**CONNECTICUT DEPARTMENT OF TRANSPORTATION
Division of Highway Design**

MEETING MINUTES

Project No.: 151-331
 Project Name: Reconstruction of Interstate 84/CT Route 8 Interchange (Mixmaster)
 Date of Meeting: March 12, 2025, 12:00 PM – 1:10 PM
 Location of Meeting: Waterville Firehouse, 1551 Thomaston Avenue
 Subject of Meeting: New Mix Project Advisory Committee (PAC) Meeting #7

Figure 6: Image of the "Modern Crossover Interchange" board with sticky note responses attached.

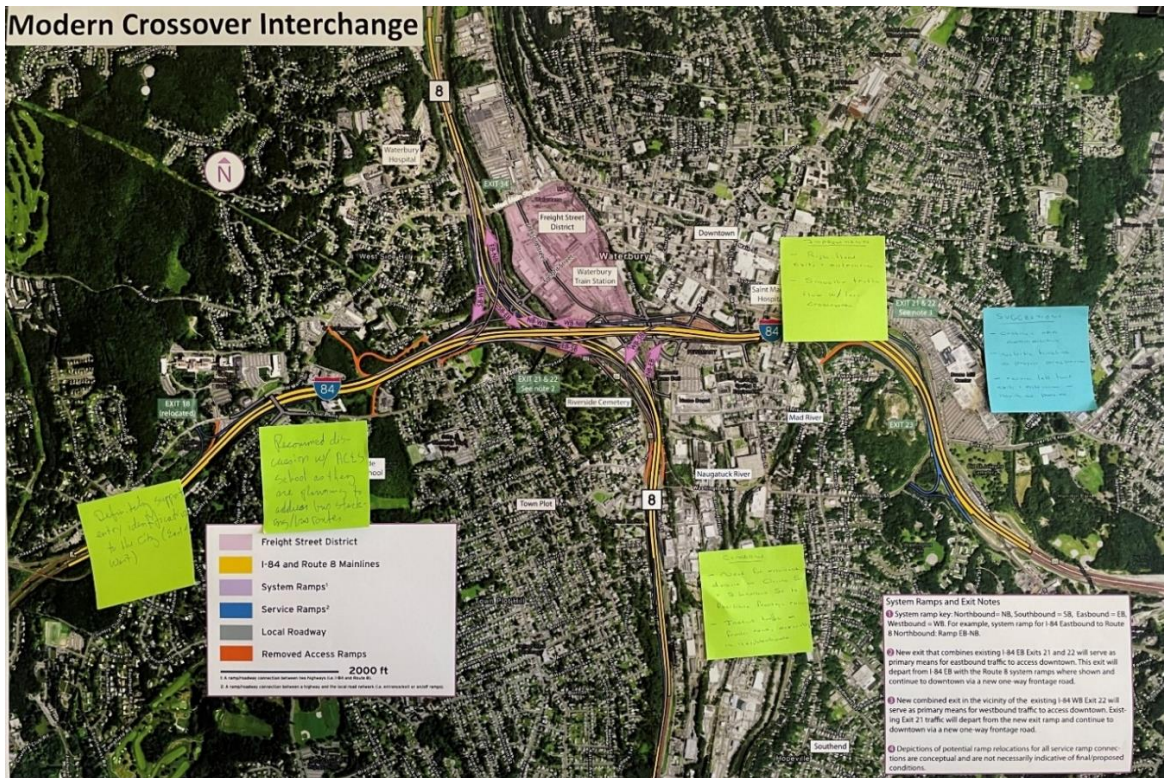
Question	Responses provided without an organization listed
A	Right hand entrances and exits
A	Smoother traffic flow with less crossover
B	Recommend discussion with ACES at Chase schools as they are planning to add on bus stacking/bus route
B	Need to eliminate eminent domain on Charles Street and South Leonard Street to facilitate frontage roads
B	Increased traffic on frontage roads, especially in neighborhoods
C	Make impacted properties public
C	Convey visual improvements in comparison to what is existing
C	Continue public outreach
C	Prioritize walkability
C	Definitely support entry identification to the city (East and West)
C	Continue open communication
C	Remove left hand exits and entrances as much as possible
C	Realistic timeline as project progresses
